ITC PROJECT STARLIGHT JSP19-17

Consideration at the request of International Transmission Company for Planning Commission's approval of Preliminary Site Plan and Stormwater Management Plan. The subject property is currently zoned OST, Office Service Technology and is located in Section 13, west of Haggerty Road and south of Twelve Mile Road. The applicant is proposing to install a solar panel array, a carport structure solar panel array, and an energy storage facility on the ITC campus.

PLAN REVIEW CENTER REPORT

Review Date: May 1, 2019
Review Type: Preliminary/Final Site Plan Review
Project Name: JSP 19-17 ITC Project Starlight
Location: 22-13-200-033 & 22-13-200-037; 27075 Haggerty, 27175 Energy Way
Plan Date: April 2, 2019
Prepared by: Lindsay Bell, Planner
E-mail: lbell@cityofnovi.org; **Phone:** (248) 347-0484

SHEET NO.
PV100

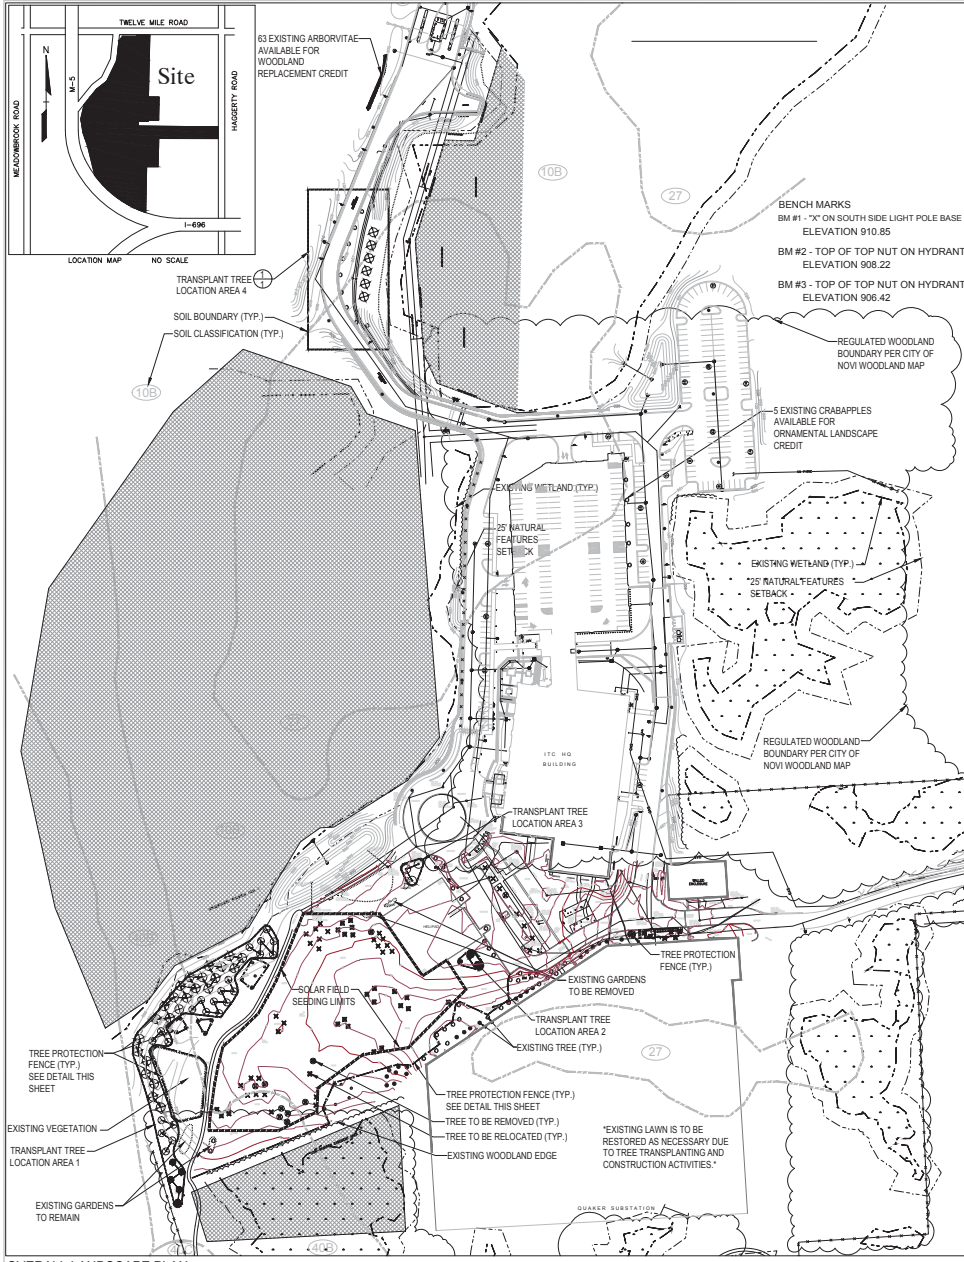
Provide total area of solar panels, carport, and battery building in order to verify

Will be noted on sheet S2 for building and sheet PV100 for canopy and array

SOLAR FIELD LANDSCAPE PLAN

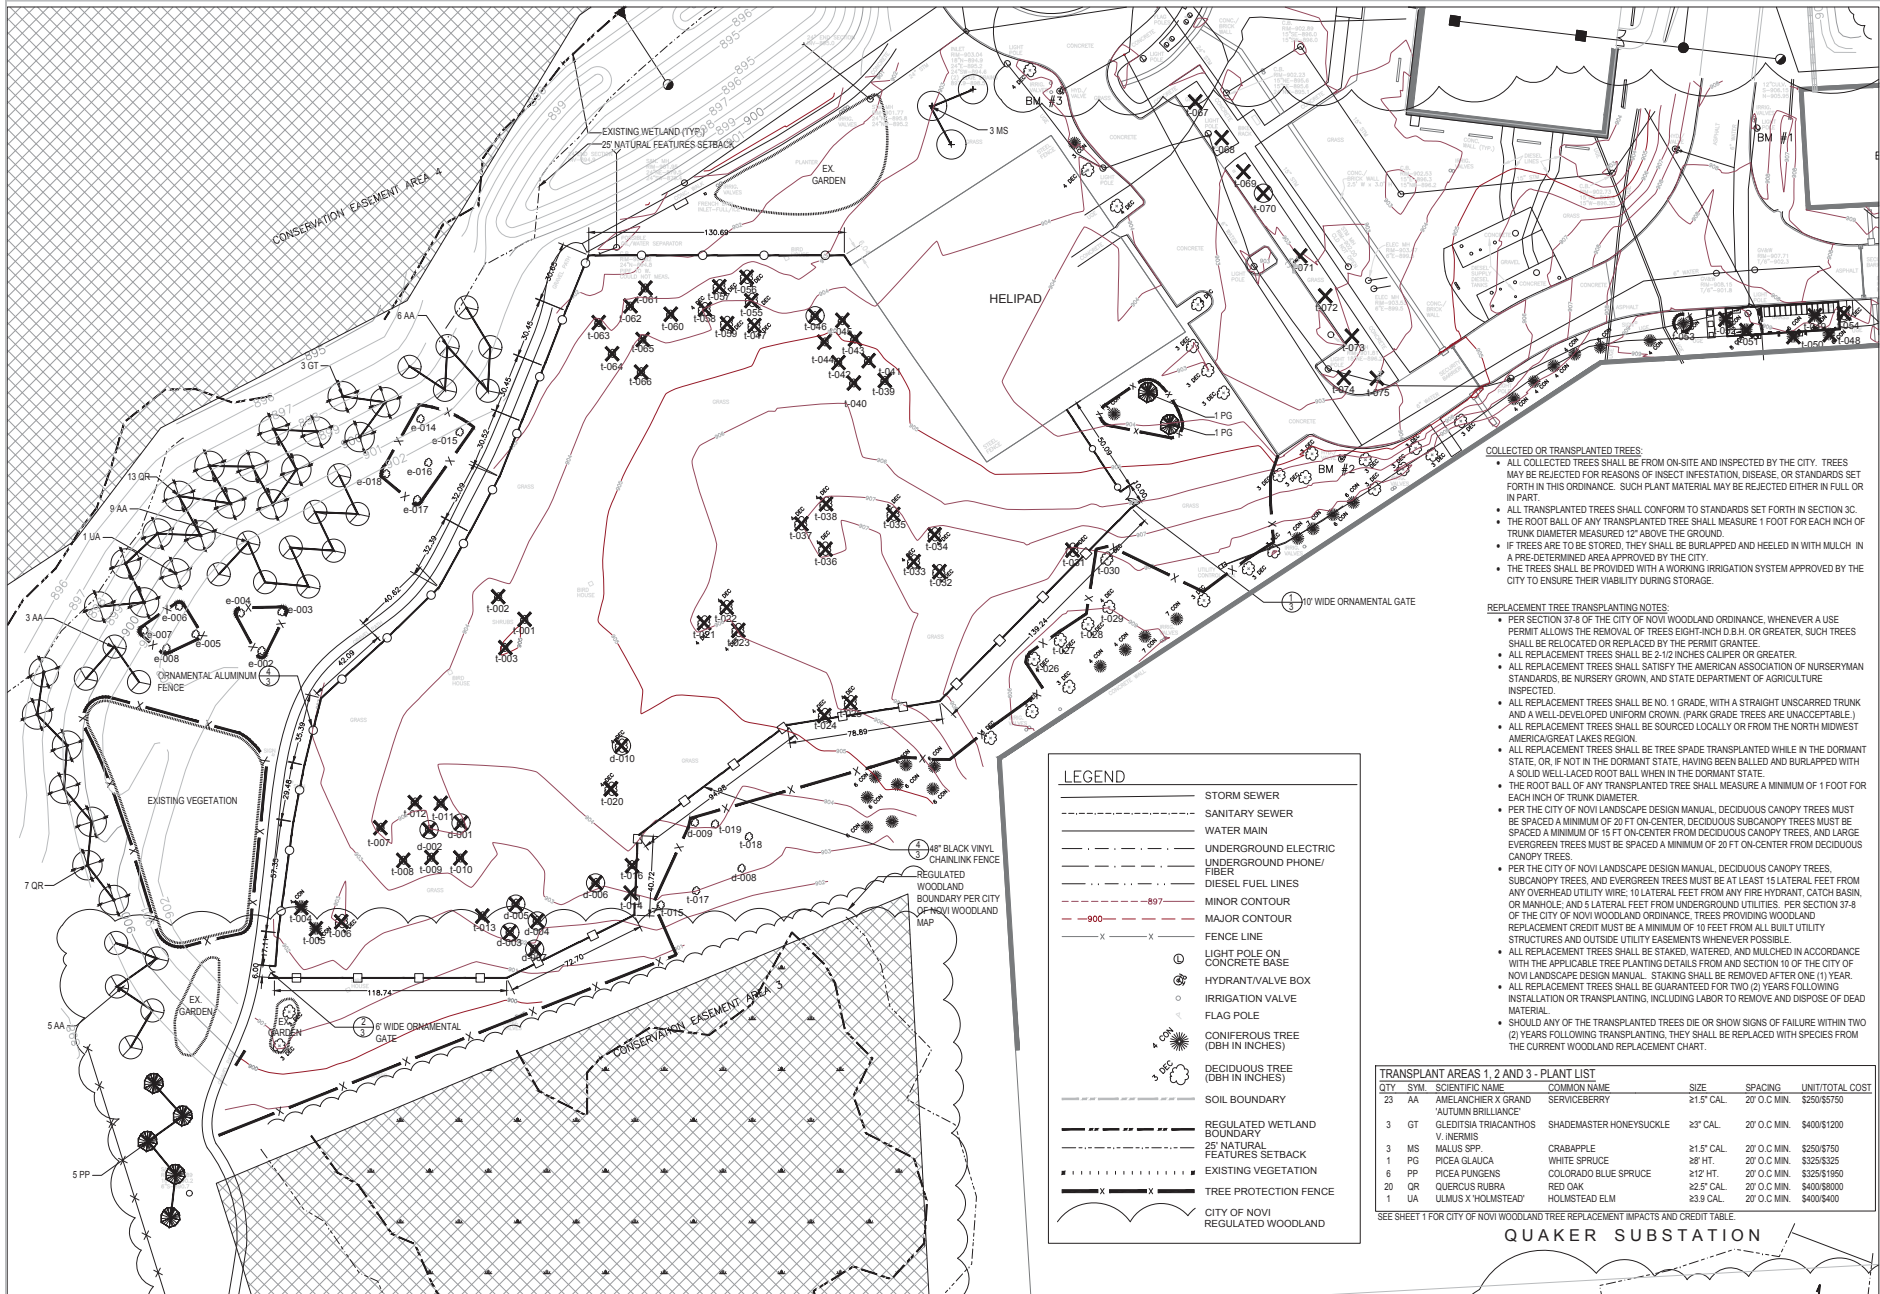
1. Native seed mixes will be planted beneath the solar array.
2. The seed mix is expected to be maintained beyond 2 years, just as woodland replacement trees are. **If the seeding fails and isn't replaced, 10 trees should be planted to replace them (the difference between the number of trees removed and transplanted) or a deposit to the tree fund is required at that time for those trees (\$400x10 = \$4000).**
3. **Please remove the note that says the 24 credits can't be used for future projects.**

If the seeding fails and isn't replaced, 10 trees should be planted to replace them (the difference between the number of trees removed and transplanted) or a deposit to the tree fund is required at that time for those trees (\$400x10 = \$4000).

Please remove the note that says the 24 credits can't be used for future projects.

Please revise that note to state that the trees shall be watered deeply once per week for the first month after transplanting, every two weeks for two months after that, and at least once per month for the remaining months of the first growing season after transplanting. (The existing note regarding seeded area watering can remain as is.) As-needed watering is acceptable for the years after the planting year.

Note will be revised
